SERVICE BULLETIN

MITSUBISHI MOTORS

PURPOSE : CORRECTION	ISSUE NO. : MSB-14EXL14-501	DATE : 2014-06-13
SUBJECT : ENGINE COOLANT CHANGE		<DESTINATION/MODEL> (EUR/MMAL/NZ) <M/Y> 14-14.5
GROUP : ENGINE COOLANT(Gr:14A)		OUTLANDER PHEV(GF0W)

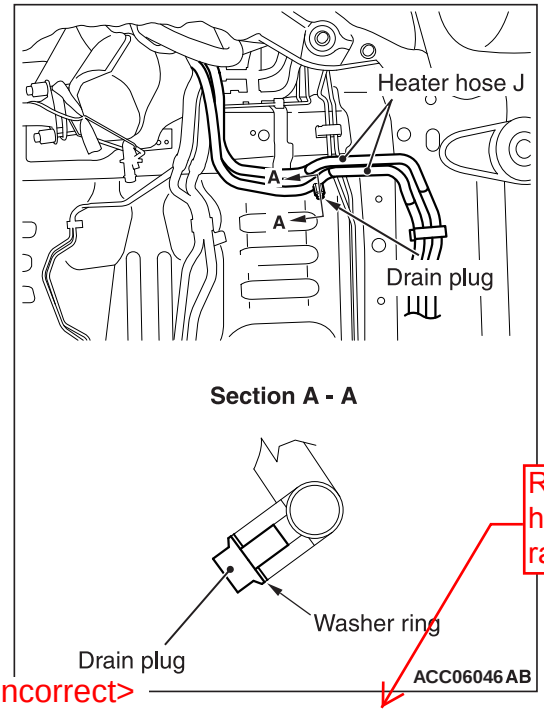
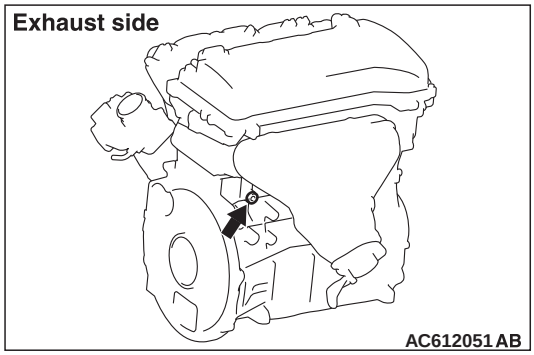
<Incorrect>

2. ~~Remove the electric heater drain plug and the radiator cap in that order.~~ Then drain the engine coolant from the radiator, the heater core and the electric heater.

<Correct>

Remove the radiator drain plug, electric heater drain plug (as shown) and the radiator cap in that order.
